REVIEW OF TIME REDUNDANCY IN AUTOMOTIVE

IEEE contribution

# ASdm - Model of hot standby redundancy for time synchronization

# Port States

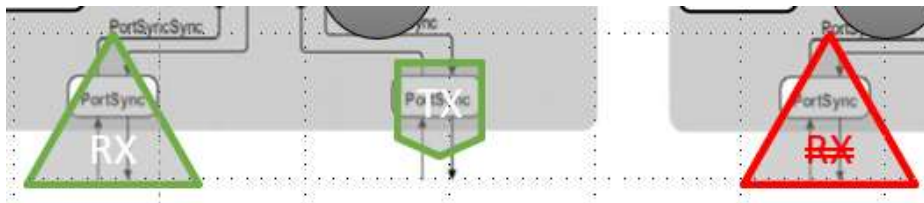
Are Port states known to the ManagementEntity?

## 17.6.3.2.2 Secondary grandmaster in NOT\_REDUNDANT state

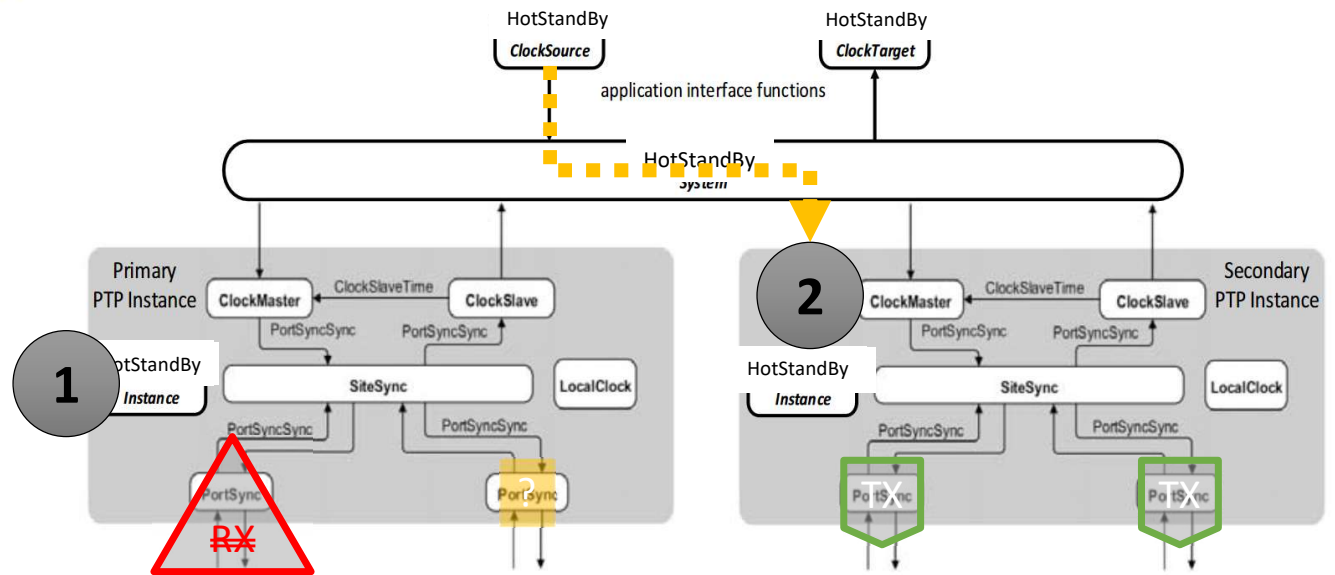
Loss of sync-input in Domain 1 causes discontinuity in Domain 2 and terminates sync-output on Domain 1, if LogSyncInterval is fixed in the network.

Figure 10-8—PortSyncSend state machine

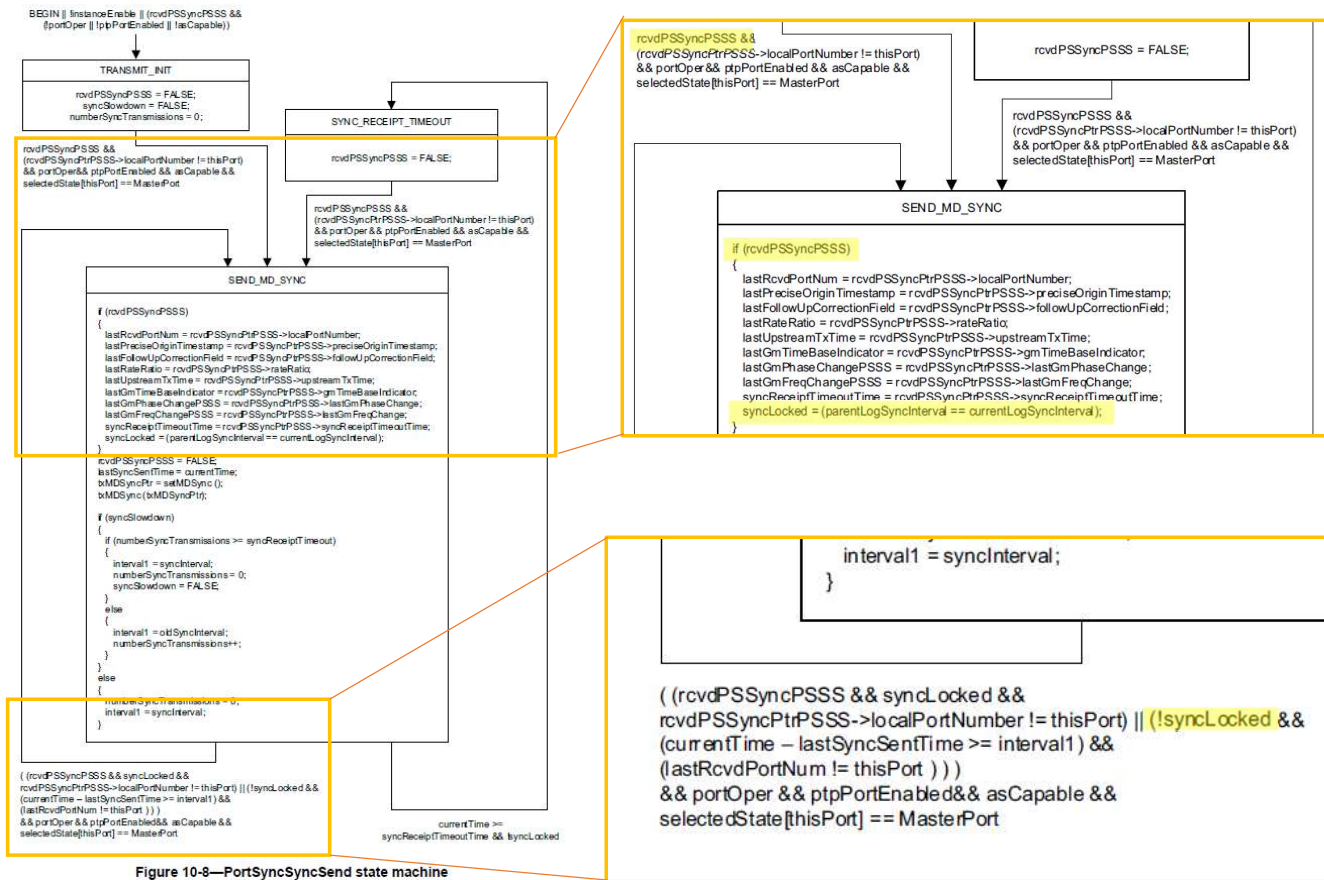
If all stations use the same LogSyncInterval, then syncLocked will always TRUE.

If syncLocked == TRUE, there will be no continued transmission of Sync- Messages.

## 17.6.3.2.2 Secondary grandmaster in NOT\_REDUNDANT state

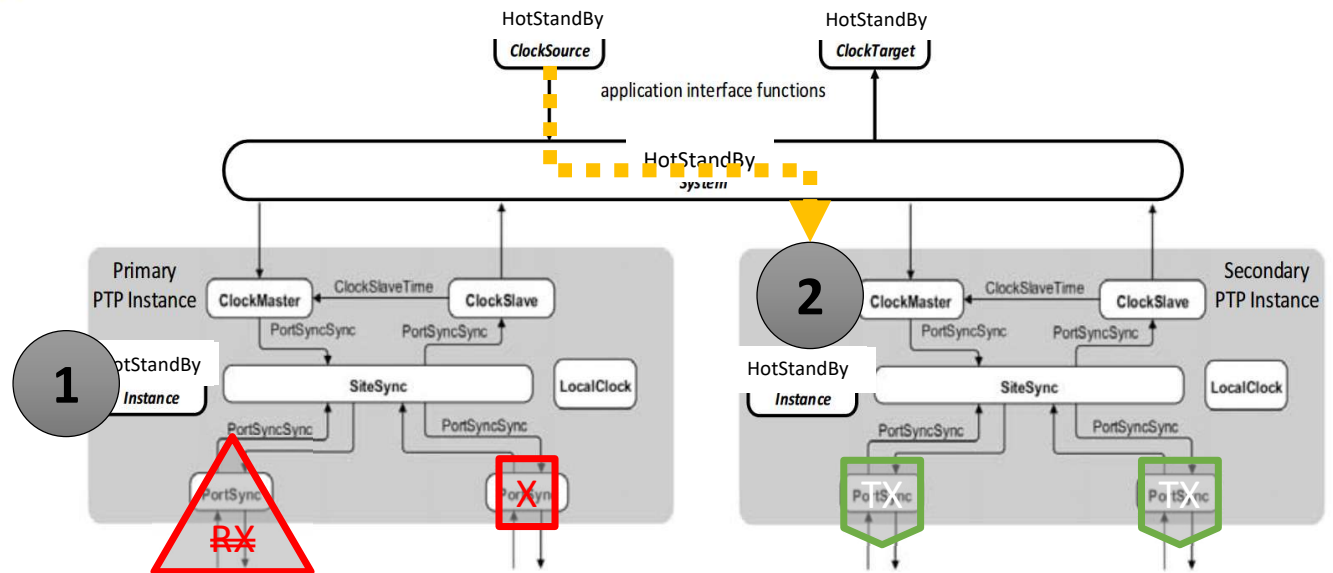
Loss of sync-input in Domain 1 causes discontinuity in Domain 2 due to input change and terminates sync-output on Domain 1, if LogSyncInterval is fixed in the network.

# Towards a new approach

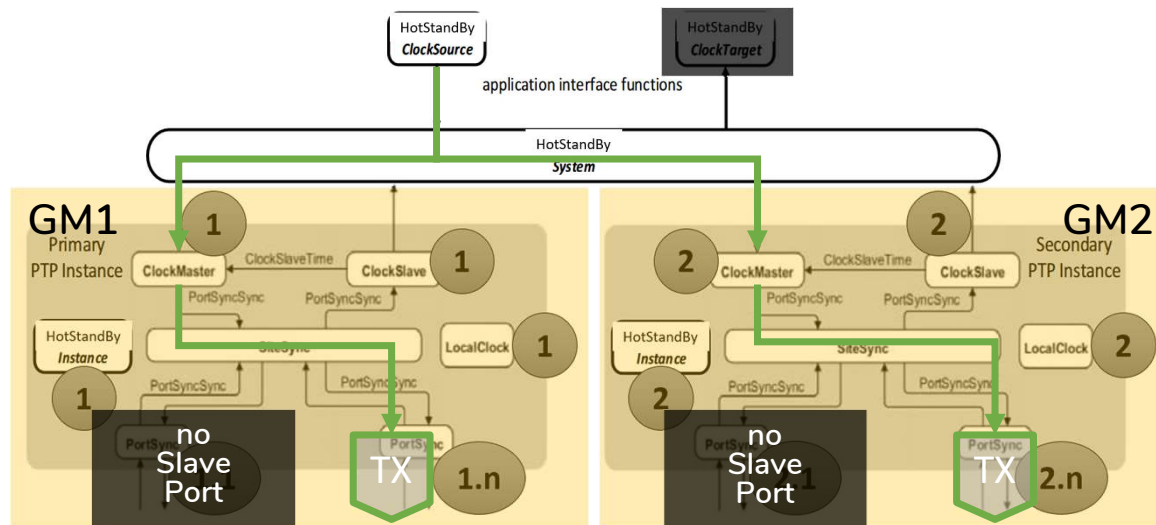
In an engineered network with a network wide statically configured LogSyncInterval and managed port states (no BMCA)

- do we need to worry about time distribution rings?
- can we (then) allow Domain 2 to Domain 1 time information transfers in some error cases?
- should we enable holdover, which would also have benefits without HotStandby (Avnu concept)?
- should we enable the comparison of the two Domains at application layer?

And could we do this within the schedule of IEEE P802.1ASdm?  
Or do we want/need a new project?
